SERVICE BULLETIN

NC-105B NAV Concentrator

**Part Number 381-5000-001 (Unit Mod 2) and
Part Number 8095679-1001 (Unit Mod 7)**

**Subassembly Mod 4 to Master Processor Module
P/N 3606423-0501**

FIGURE 1
VIEWED FROM SOLDER SIDE

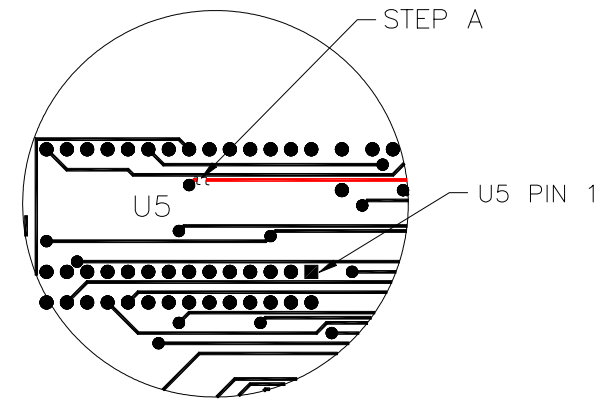
ON THE SOLDER SIDE OF THE BOARD, IMPLEMENT THE CUT LISTED IN THE CUT TABLE (TABLE I) AS SHOWN IN FIGURE 1. COVER ALL CUTS WITH FIND NO 6. USE THE LISTED CONTINUITY POINTS AS VERIFICATION THAT CONTINUITY HAS BEEN BROKEN.

CUT TABLE I		
FROM	TO	CONTINUITY POINTS
VIA UNDER U5	U5-22	U2-5 TO U5-22
U11-9	VIA	U11-9 TO TP19

FIGURE 2
VIEWED FROM COMPONENT SIDE

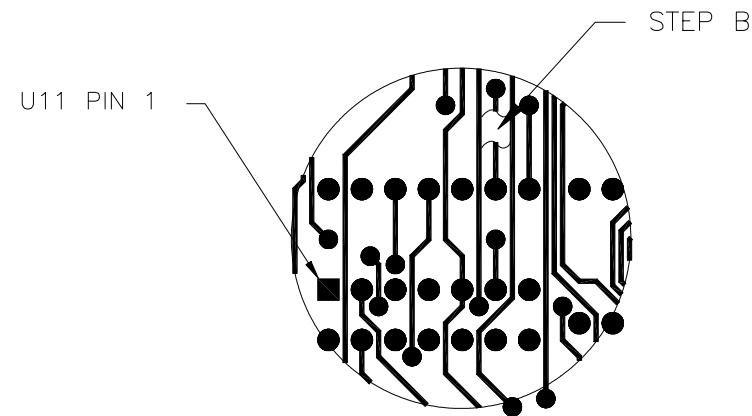
ON THE COMPONENT SIDE OF THE BOARD, IMPLEMENT THE CUT LISTED IN THE CUT TABLE (TABLE I) AS SHOWN IN FIGURE 2. COVER ALL CUTS WITH FIND NO 6. USE THE LISTED CONTINUITY POINTS AS VERIFICATION THAT CONTINUITY HAS BEEN BROKEN.

FIGURE 3
VIEWED FROM SOLDER SIDE

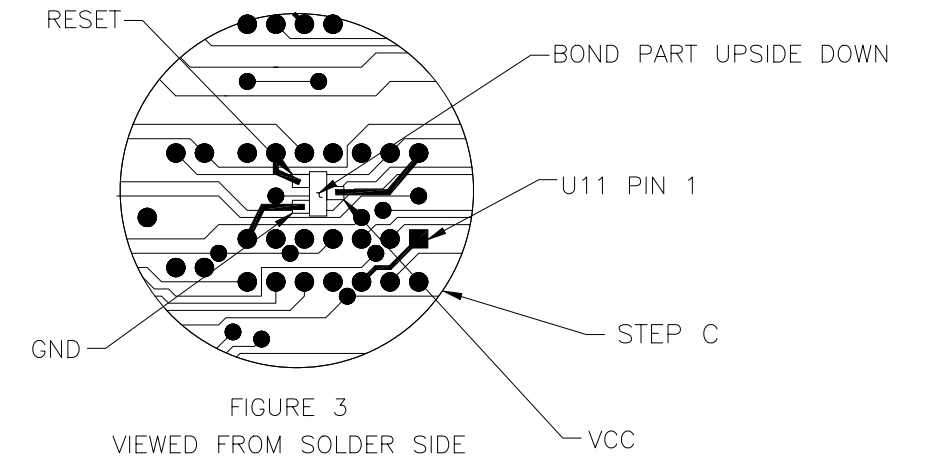
ON THE SOLDER SIDE OF THE BOARD INSTALL COMPONENT (F/N 70) & JUMPERS IAW THE JUMPER TABLE (TABLE III) USING FIND NO 7 AS SHOWN IN FIGURE 3. TACK BOND THE JUMPERS TO THE BOARD AS NEEDED USING FIND NO 8. VERIFY THE JUMPERS BY TESTING BOARD CONTINUITY AS INDICATED IN TABLE III.

JUMPER TABLE II		
FROM	TO	CONTINUITY POINTS
U5-22	U9-22	U5-22 TO U2-3
U24-GND	U11-7	
U24-VCC	U11-14	
U24-RESET	U11-9
